**Subject: MHI's Response to US-APWR DCD RAI No. 887-6261 Revision 3 (SRP 09.01.04)**

Response to Request for Additional Information No. 887-6261  
Revision 3

**RAI NO.:** NO. 887-6261 REVISION 3  
**SRP SECTION:** 09.01.04 – LIGHT LOAD HANDLING SYSTEM (RELATED TO REFUELING)  
**APPLICATION SECTION:** 09.01.04  
**DATE OF RAI ISSUE:** 01/10/2012

**QUESTION NO.: 09.01.04- 23**

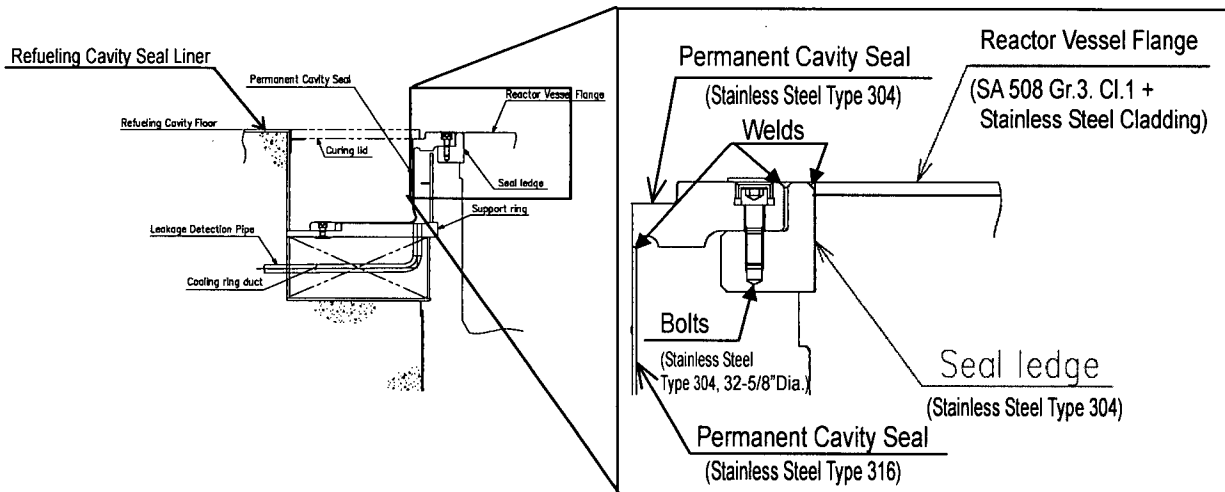
Based on the above elements, especially from the text and the figure that will be added to DCD Section 9.1.4.2.1, the staff deduced that some parts of the PCS are welded/bolted to the reactor vessel. However, the staff was not able to identify precisely which parts and how they are attached to the reactor vessel. Therefore, it is not clear to the staff whether the PCS design and installation could adversely affect the reactor vessel material and its integrity. The staff also noted that in revised Table 3.2-2 the applicant kept the identification number for "Codes and standards" as "5" corresponding to "codes and standards as in defined bases" and did not modify this number to "3" corresponding to "ASME Code, Section III, Class 3." The staff considers that this is not consistent with the new categorization of the PCS as a Class 3 component, according to which the relevant ASME Code criteria should be selected.

Because of the importance of the interfaces between the PCS and the reactor vessel, the staff requests the applicant provide the following information to assure that the fabrication and installation of this PCS will not adversely impact the reactor vessel material or structural

integrity (e.g., to behave in a brittle manner or increase the probability of rapidly propagating failure):

- Describe in detail the PCS, especially the seal ledge, including the identification of the materials that are used;
- Identify any fasteners, bolts or welds used in the PCS;
- Describe in detail the connections between the PCS and the reactor vessel, particularly with the reactor vessel pressure retaining portion. If welding is used, describe any design considerations (such as weld joint type or location) or controls on welding (such as weld size or heat input limitations) that assure that welding has no adverse impact on the reactor vessel material or integrity.
- Justify why the identification number for "Codes and standards" in revised Table 3.2-2 does not correspond to the identification number for a Class 3 equipment implying that ASME Code Section III, Class 3 will not be applied to the PCS.

The detail configuration and materials of the Permanent Cavity Seal (PCS) around the Seal Ledge (SL) are described below. The SL is ring type configuration attached to outside of the Reactor Vessel (RV) and made out of stainless steel. The SL is supported by the RV at the bottom, welded to the PCS and the RV flange at the top, and bolted to the PCS. The welding at the top of the SL are continuous welds and used for sealing the cavity water.

There are partial penetration continuous welds and bolts connecting the PCS, the SL, and the RV. The first connecting weld (between the SL and the RV) and the second connecting weld (between the PCS and the SL) are both used for sealing but not for structural support. The SL is supported by the RV at the bottom, and is designed so that the weld is within the cladding of the RV, which does not affect the structural integrity of the RV. The PCS is bolted and seal welded to the SL since it can only be installed at site. The welding between the SL and the RV will be controlled and inspected based on ASME because of the first connecting weld to pressure retaining portion.

Since the PCS is not a pressure-retaining component for the Reactor Coolant System (RCS), ASME BPVC Section III does not apply to the seal itself. In terms of the relationship with the reactor vessel, to which ASME BPVC Section III, Subsection NB applies, the ASME BPVC Section III is not applicable to the PCS and the connecting weld between the seal and the SL for the following reasons:

- The PCS is indirectly attached to the reactor vessel through the SL, as shown in the figure above.
- The SL has neither pressure-retaining function nor structural function.
- In accordance with ASME BPVC Section III, NB-1132.2 (e), stating that "The first connecting weld of a welded nonstructural attachment to a component shall be considered part of the attachment. At or within  $2t$  from the pressure-retaining portion of the component, the first connecting weld shall conform to NB-4430.", the SL and its connecting weld to the RV is not a part of the vessel, but an attachment to the vessel.
- Moreover, while the first connecting weld (in this case, the connecting weld between the SL and the vessel) is required to conform to NB-4430, there is no requirement for the second connecting weld, namely, the connecting weld between the SL and the PCS.
